Lower Thames Crossing

9.69 Final Agreed Statement of Common Ground between (1) National Highways and (2) Harlex Haulage and (3) J & B Martin (Crayford & Fawkham) Limited (Clean version)

**DATE: December 2023
DEADLINE: 9A**

Planning Inspectorate Scheme Ref: TR010032
Examination Document Ref: TR010032/EXAM/9.69

Appendix B Harlex Vehicle Tracking

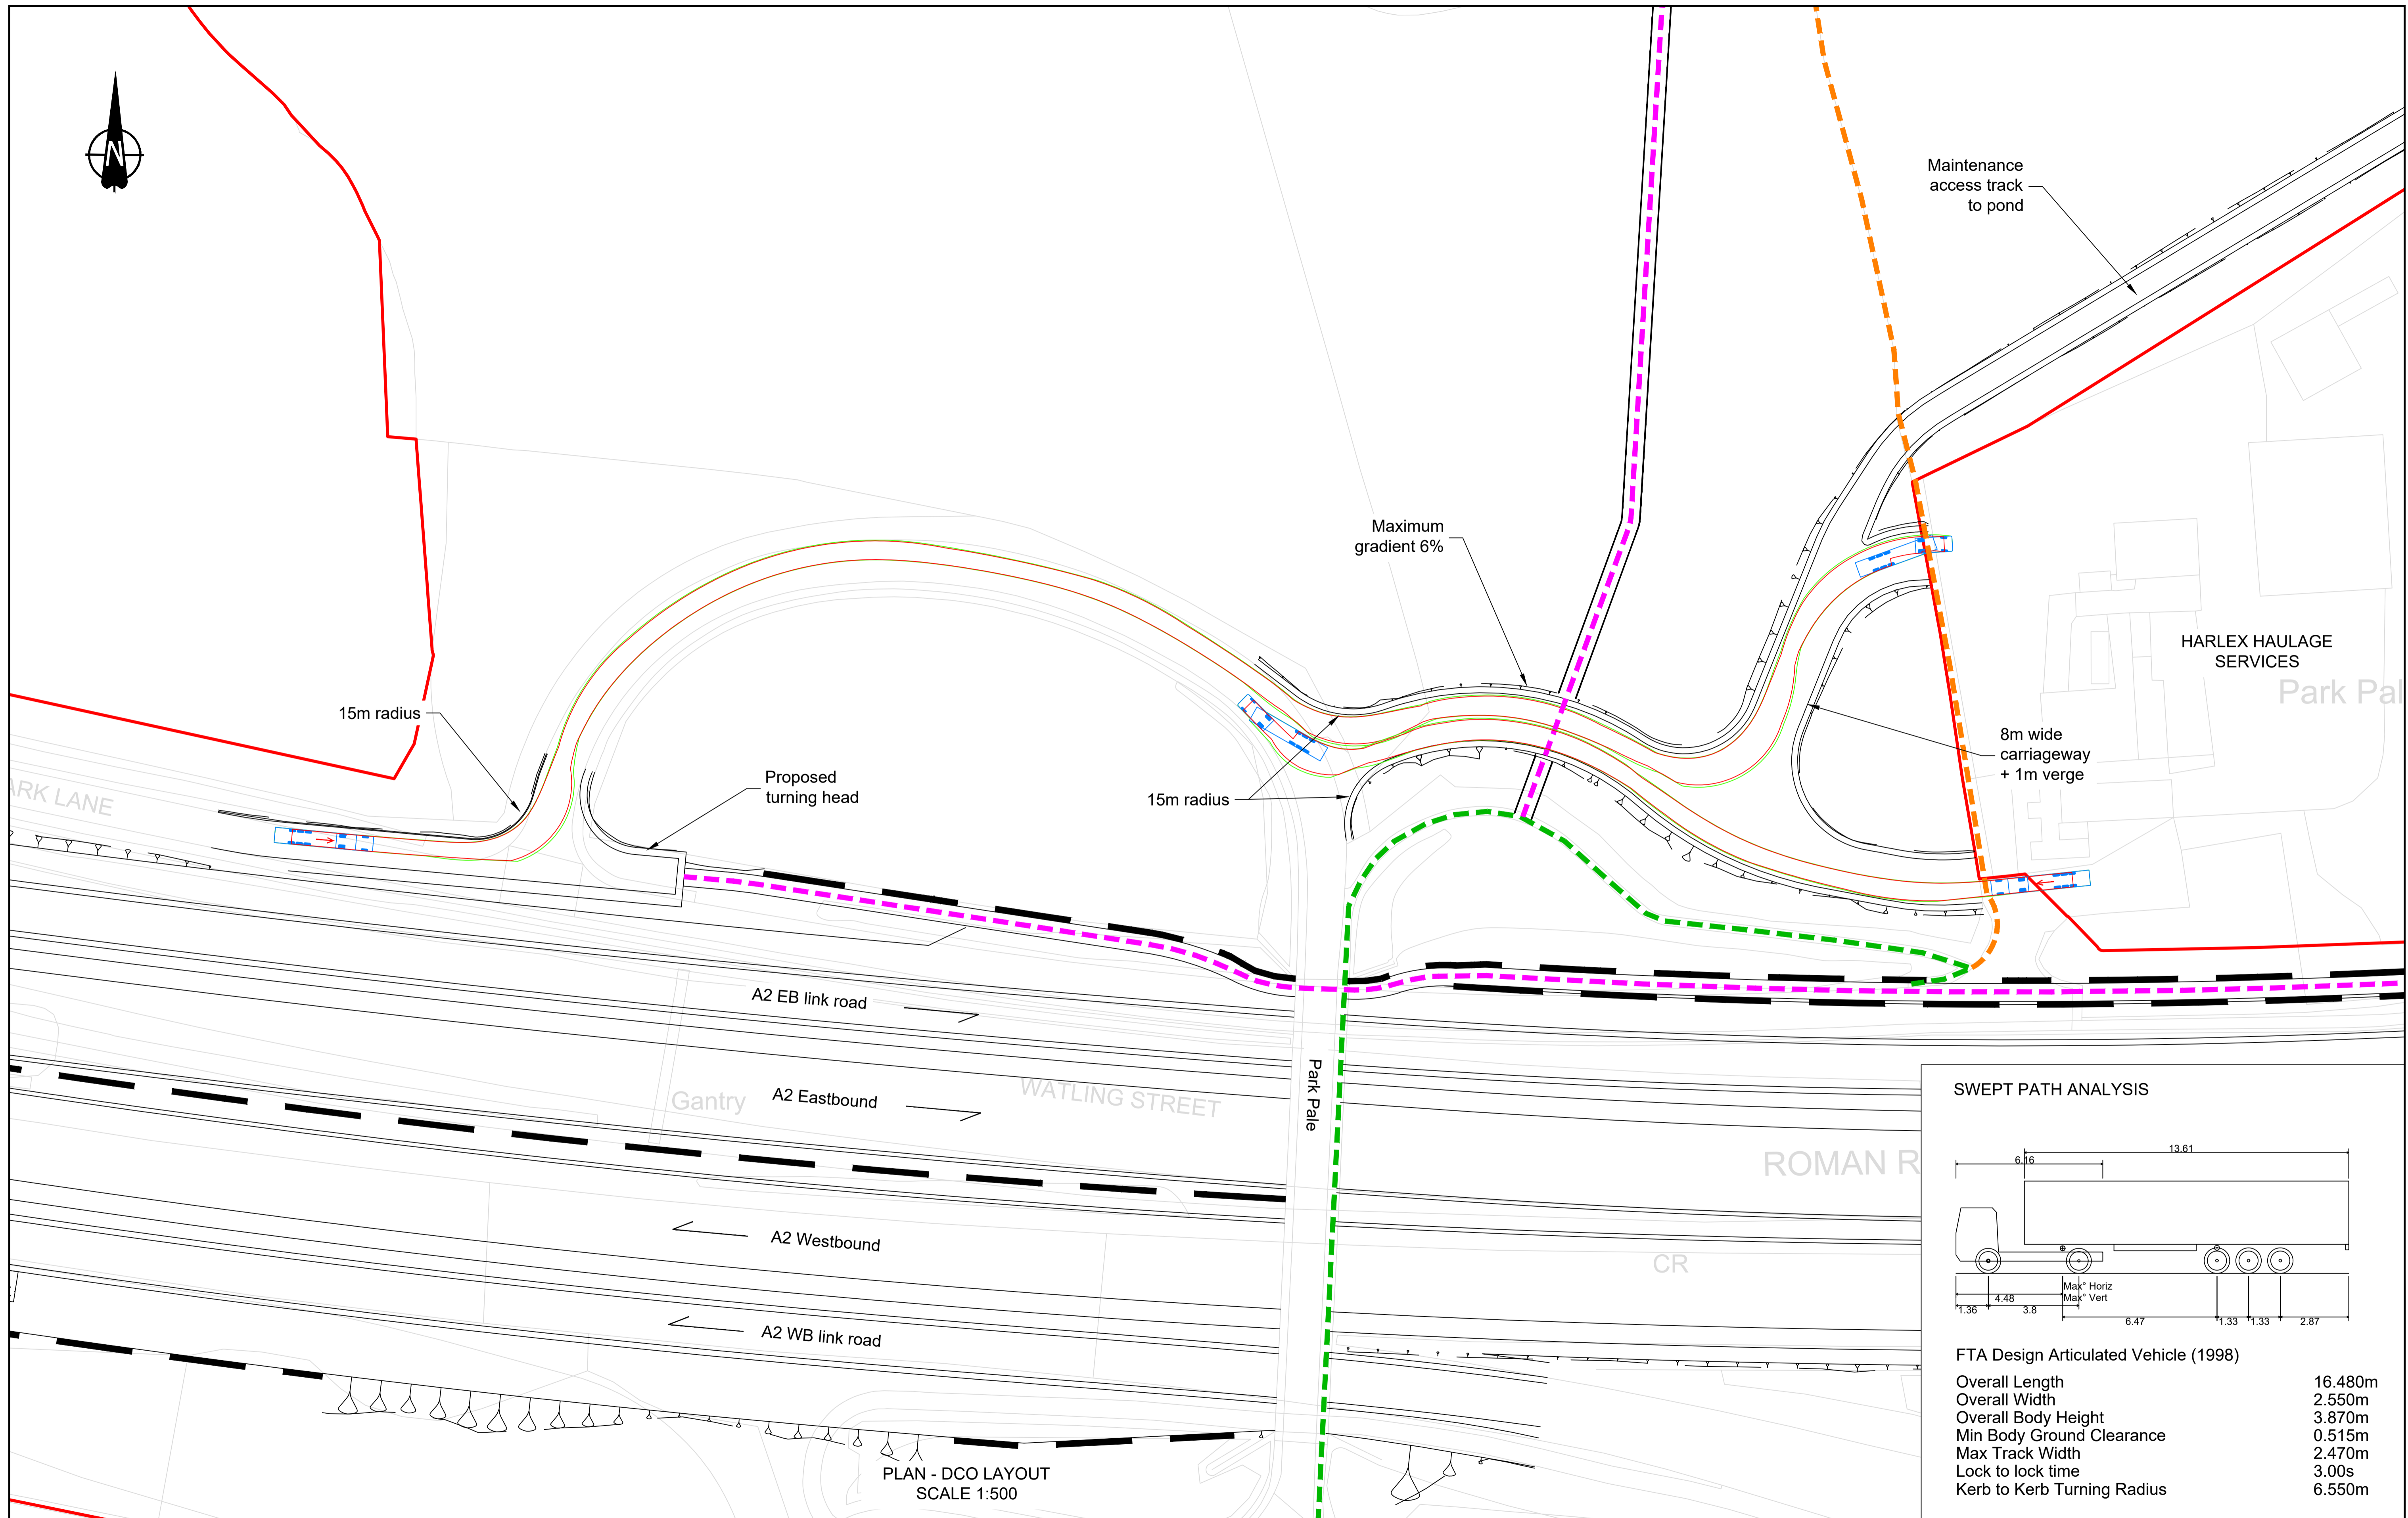
Topic	Item No.	Harlex Haulage Limited, and J & B Martin (Crayford & Fawkham) Limited Comment	The Applicant’s Response	Application Document Reference	Status
		<p>from the golf club. The interested party has no confidence that the levels and sweep paths will work to enable a safe and viable entrance and exit to the Harlex yard. The Applicant must commit to guaranteeing it is safe and will work within the Design Principles. In addition, the Applicant must commit to providing a design that is workable for the unrestricted use of the haulage yard where the access turns left off Park Pale Road up the incline to the new entrance and that this meets all necessary design requirements.</p>	<p>Harlex demonstrating articulated vehicles, measuring 16.48m in length, can navigate the replacement access as delineated on Sheet 3 of the General Arrangement Plans.</p> <p>In respect of the Interested Party’s comments as to workable design from Park Pale up the incline to the new entrance, the junction on Park Pale is of a similar geometric design to the geometry of the junction between Park Pale and Brewers Road, which is regularly used by Harlex vehicles currently.</p> <p>As this is not a private right of way, the implementation of works falls under article 10(1) of the draft DCO. Therefore, these works will be required to be completed to the reasonable satisfaction of Kent County Council as the statutory highway authority responsible for Park Pale. It should be noted that article 10 of the draft DCO is to be read together with Schedule 14, Part 11 of the draft DCO (Protective Provisions for Local Highway Authorities) which provides a robust and prescribed process whereby the Applicant would be required to remedy any defects identified by Kent County Council as local highway authority. It should also be noted that clause 150(2)(a) of Schedule 14, Part 11</p>

Topic	Item No.	Harlex Haulage Limited, and J & B Martin (Crayford & Fawkham) Limited Comment	The Applicant's Response	Application Document Reference	Status
			of the draft DCO requires a stage 3 road safety audit to have been carried. The Applicant therefore considers that it has already committed to providing a design that will be workable and would be to the satisfaction of Kent County Council as the relevant Highway Authority.		
Design					
Balancing Pond	2.1.2	Harlex were unhappy with the original balancing pond design and requested it to be moved further east.	The Applicant accommodated this design request before Supplemental Consultation (January 2020) and the balancing pond Work No 1I as shown on Sheet 3 of the Works Plans is now further east than it was originally proposed.	Works Plans Volume B Composite [Document Reference 2.6 Volume B Composite (6)]	Matter Agreed
Replacement Access – Updated Entrance & Exit Design Request	2..1.3	Harlex propose a new updated entrance and exit design for the replacement access. The reason for this request was that there was no alternative and that the Applicant had not appreciated the design requirements during early design. The interested party remains sceptical the sweep paths and vehicle tracking will work in practice from Park Pale Road and into the haulage yard	The current design (Work No 1C as shown on Sheet 3 of the Works Plans) was proposed by Harlex and accommodated by the Applicant at Community Impacts Consultation (June 2021). The Applicant has undertaken vehicle tracking and shared the same demonstrating articulated vehicles, measuring 15.5m in length, can navigate the replacement access in its current design. Please refer to Appendix B.	Works Plans Volume B Composite [Document Reference 2.6 Volume B Composite (6)]	Matter Not Agreed

Topic	Item No.	Harlex Haulage Limited, and J & B Martin (Crayford & Fawkham) Limited Comment	The Applicant’s Response	Application Document Reference	Status
			<p>This further request to change the design, as illustrated in Appendix C, received on 7 February 2023, will have many impacts and the Applicant has a number of design concerns over the design of the access proposed by Harlex. Splitting the carriageway until the junction will lead to vehicles entering and exiting the junction on the wrong side of the road (as Harlex switch their direction of one way operation), which would be a safety risk. The current design ensures that all vehicles are on the correct side of the carriageway at the junction. As the access will also be used by the Applicant for maintenance of ponds, it would also mean that maintenance vehicles would either have to travel against the flow of traffic or go through the Harlex site to avoid conflict. Splitting the carriageway also means pedestrians using the footpath will have to cross two carriageways which is avoided in the current proposal. It may also need to be consulted on and will incur additional cost (compared to current design) and introduce consultation uncertainty.</p> <p>The replacement access to Harlex Haulage is a private/maintenance access track; therefore, it does not fall under the</p>

Topic	Item No.	Harlex Haulage Limited, and J & B Martin (Crayford & Fawkham) Limited Comment	The Applicant’s Response	Application Document Reference	Status
			<p>requirements of the Design Manual for Roads and Bridges (DMRB). However, to promote a conservative design approach at this stage of preliminary design, DMRB CD 123 recommendation at clause 5.2 has been considered: <i>“Allowance shall be made for the swept turning paths of the worst case design vehicle which is expected to use the priority junction.”</i></p> <p>The worst case scenario was not available at the time of the design; therefore, a standard design vehicle has been used in accordance with DMRB CD 123, which states: <i>“The design vehicle for at-grade priority and signal controlled junctions is a 16.5m long articulated Heavy Goods Vehicle.”</i></p> <p>As noted under paragraph 5.6.2 in DMRB CD 123: <i>“At simple priority junctions where provision is made for the design vehicle, the corner radii should be 15 metres in rural areas followed by a corner taper of 1:10 over a distance of 25 metres.”</i></p> <p>The uses of this junction will be limited to Harlex Haulage and National Highways maintenance vehicles only. Members of the public and general road users should not be using this access; therefore, this is a private means of access. As this</p>

Topic	Item No.	Harlex Haulage Limited, and J & B Martin (Crayford & Fawkham) Limited Comment	The Applicant's Response	Application Document Reference	Status
			<p>junction does not sit on the Strategic Road Network nor form a through route the design has been developed to safely fit within the surrounding constraints.</p> <p>With all the considerations above, it is therefore concluded that the design of the access to Harlex is safe and in line with good practice and current standards.</p>		
Replacement Access – Tie in works	2.1.4	<p>Harlex suggest there would be level issues with ensuring the new access ties into the site.</p> <p>The previous draft proposals provided by the Applicant need to be updated and take account of the further meetings held since April 2021.</p>	<p>The Applicant's design accommodation letter for the replacement access road specifically deals with this issue and mitigates disruption. This was issued on 1 April 2021 with subsequent reminders.</p> <p>The Applicant will update and recirculate the design accommodation letter for the landowner to sign and return so it can transfer the commitments therein to Contractors and an associated Project Manager lead to ensure compliance.</p>	N/A	Matter Agreed*
